KERR-MCGEE CHEMICAL CORPORATION, WEST CHICAGO, ILLINOIS  
LICENSE NO. STA-583 (DOCKET NO. 40-2061)  
REQUEST FOR RADIATION SURVEYS OF BUILDINGS NO. 11, 12,  
20 AND 21 AT KERR-MCGEE THORIUM FACILITY  
(AITS NO. HO1317F3)

KERR-MCGEE CHEMICAL CORPORATION, WEST CHICAGO, ILLINOIS  
LICENSE NO. STA-583 (DOCKET NO. 40-2061)  
REQUEST FOR RADIATION SURVEYS OF BUILDINGS NO. 11, 12, 20  
AND 21 AT KERR-MCGEE THORIUM FACILITY

FIGURE 1

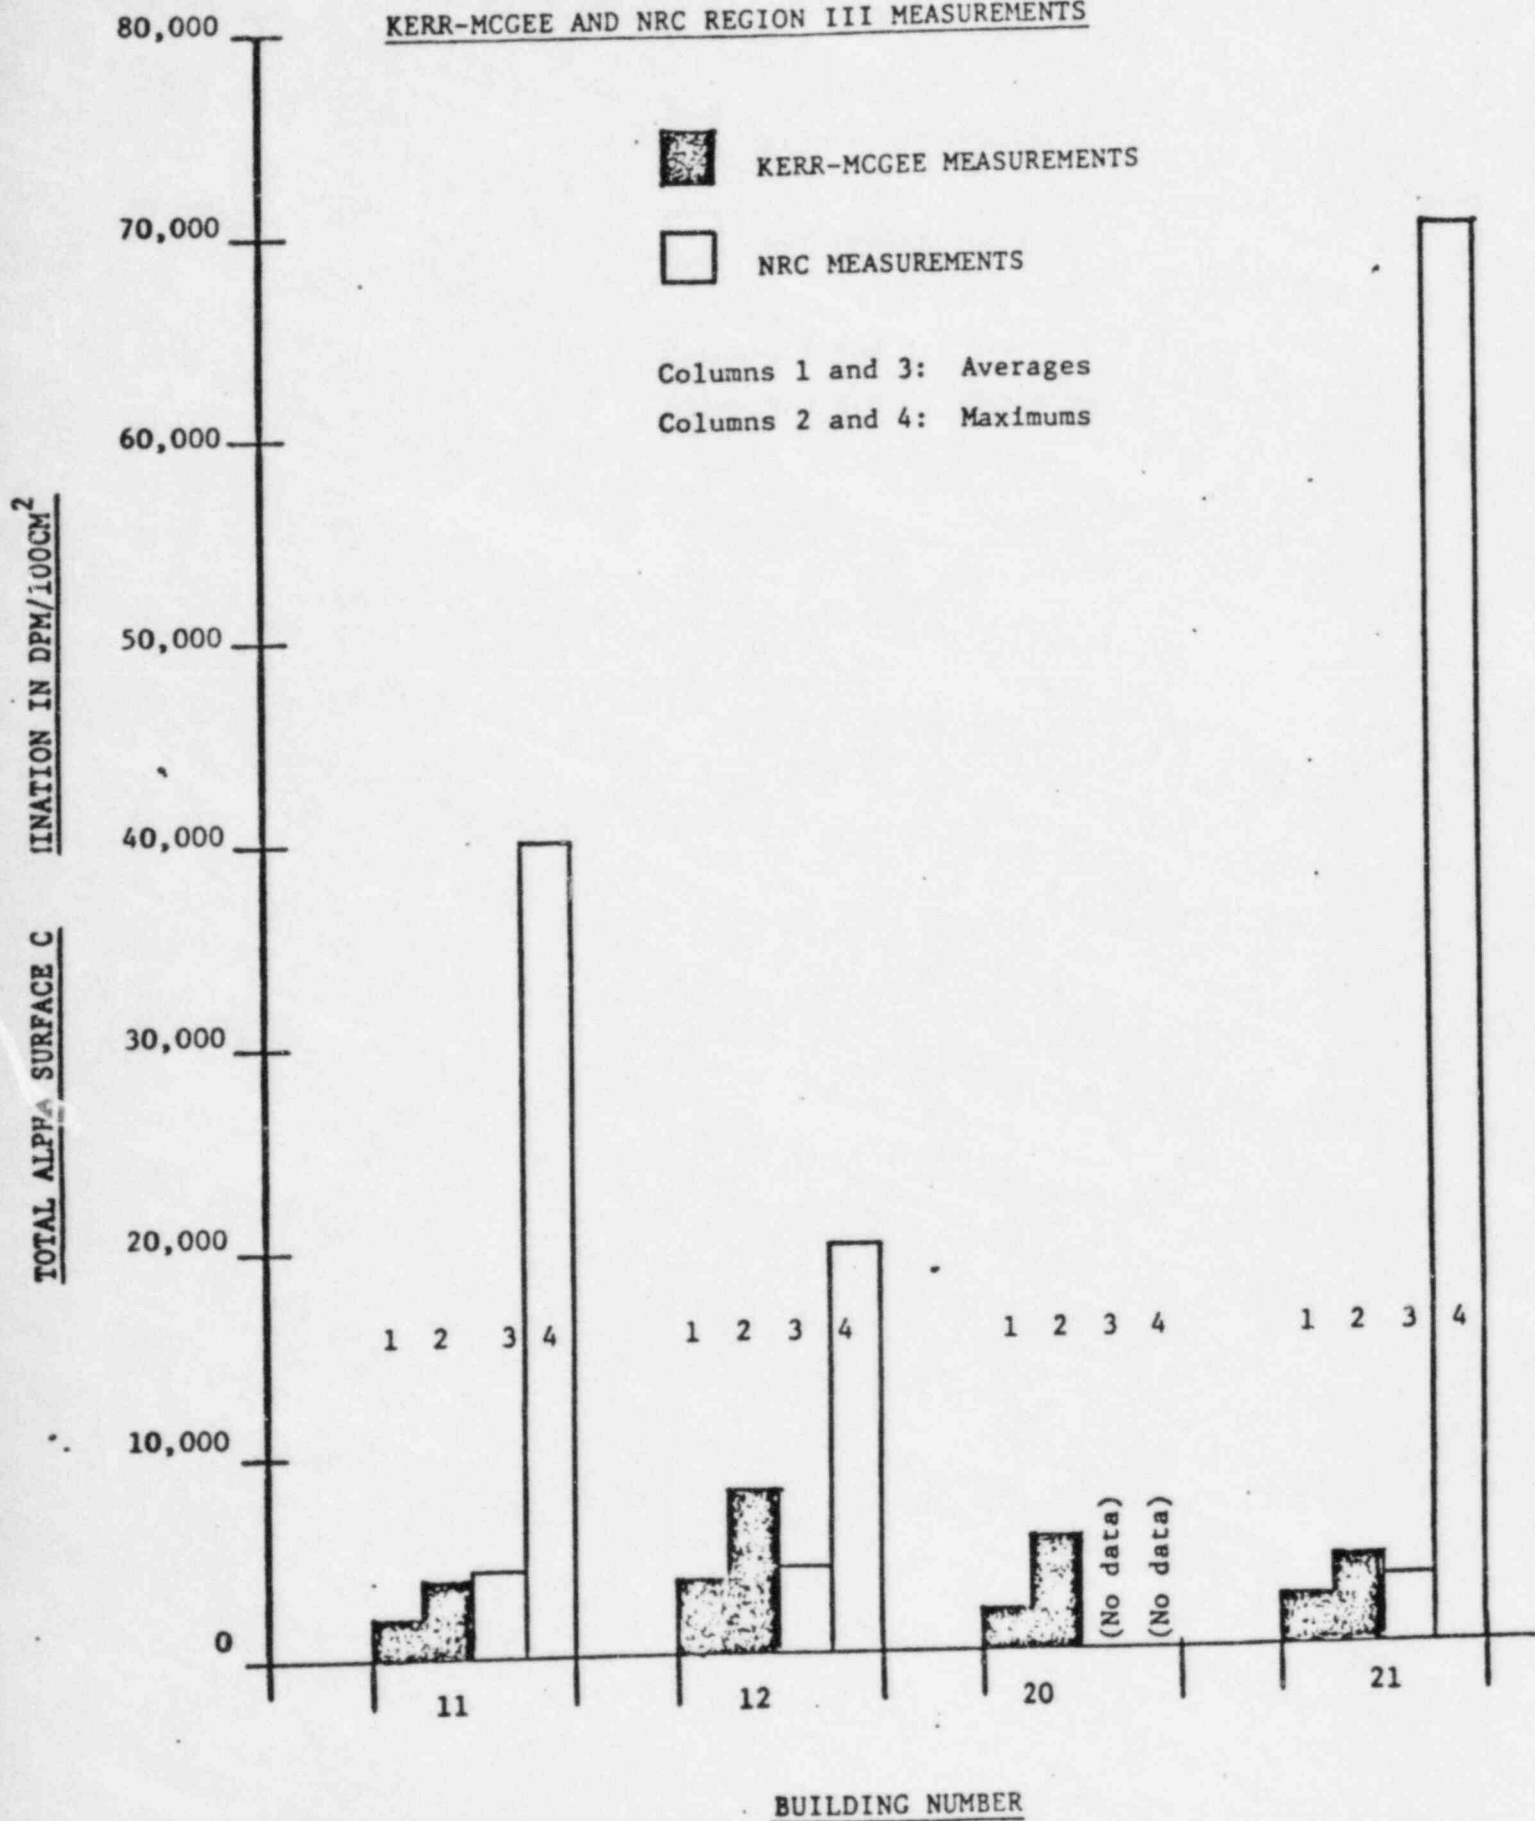
By comparison to data presented in Table I, the "Preliminary Survey" performed by Kerr-McGee personnel in the West Chicago facility is presented in Table II. The total alpha surface contamination data is graphically compared in Figure 1.
